Product Change Notice (PCN)

PCN Number: PCN-*045-1167R*-01

Product(s) Affected: *PJ-042H*

PREVIOUS CUI DEVICES DETAIL / IMAGE	NEW CUI DEVICES DETAIL / IMAGE

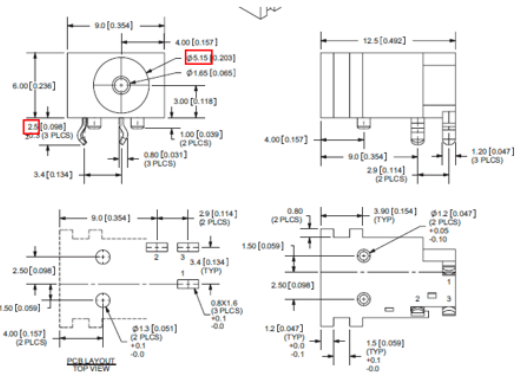
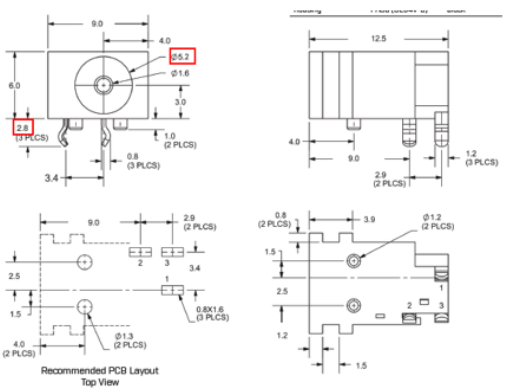
Description of Change: *Minor Structural and material Difference. See image Below*

MATERIAL	PLATING
center pin	brass	tin
terminal 1	brass	tin
terminal 2	copper alloy	tin
terminal 3	brass	tin
plastic	PA66

MATING PLUG
Jack Insertion Depth: 8.00 mm

DESCRIPTION	MATERIAL	PLATING/COLOR
center pin	brass	tin
terminal 1	brass	tin
terminal 2	phosphor bronze t=0.3	tin
terminal 3	brass t=0.3	tin
housing	PA66 (UL94V-0)	black

MATING PLUG
Jack Insertion Depth: 7.8 mm
